PERMIT

SEWAGE DISPOSAL SYSTEM

MARYLAND STATE DEPARTMENT OF HEALTH*

SUBDIVISION Evergreen Valley Estates ROAD 3218 Evergreen Way LOT _____

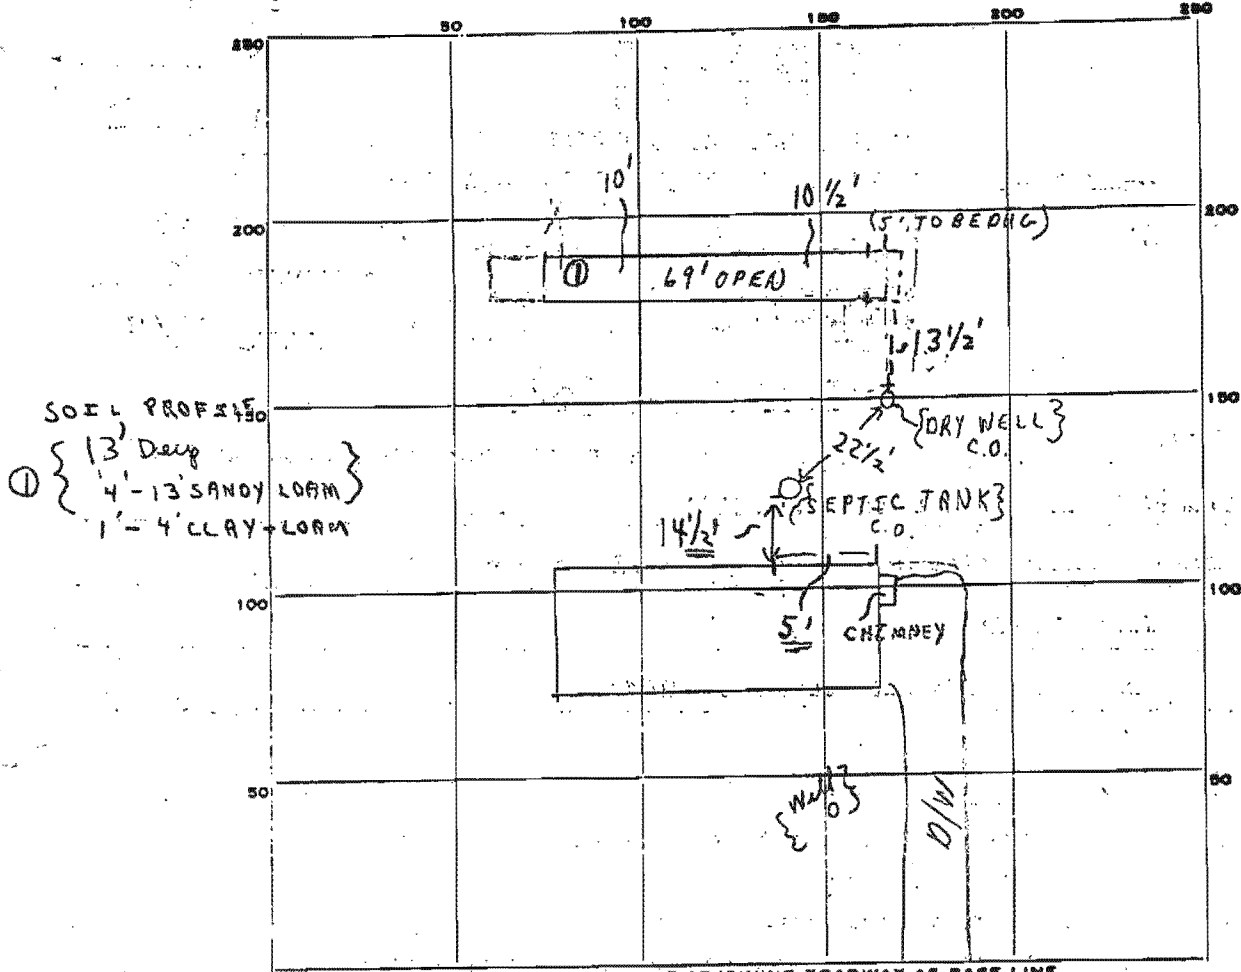
PACING LOT FROM 5' OFF DRYWELL IN AREA AS SHOWN ON BACK OF THIS SHEET

1 Trench 75'-80' LONG, 2' WIDE, 6' OF STONE UNDER PIPE

Note: - need approved clearouts to grade on (septic tank) + dry well.

TRENCH TYPE FIELD, DEPTH 10'-10 1/2' FT. TRENCH WIDTH 2 FT. (Need more 6'-11' LENGTH)

GRAVEL DEPTH 1/4" TOTAL LENGTH 69 FT. (open)

REMARKS 8/6/81 HOLD FOR RESCHEDULE; 8/7/81 MAN CHECKED - SEPTIC TANK CLEANOUT ON
AND DRY WELL CLEANOUT ON; (1) P.M. - HOLE 13' DEEP DUG, OK FOR TRENCH;
8/7/81 (2) P.M. - TRENCH 69' LONG; OWNER TO VERIFY REST OF TRENCH-LENGTH; DEPTH;
DEPTH OF STONE; TYPE OF PIPE USED PARTIAL, 8/10/81 SYSTEM COVERED - MR FADELY OWNER
CERTIFIED ABOVE - SEE BACK OF ATTACHED PERMIT CARD.
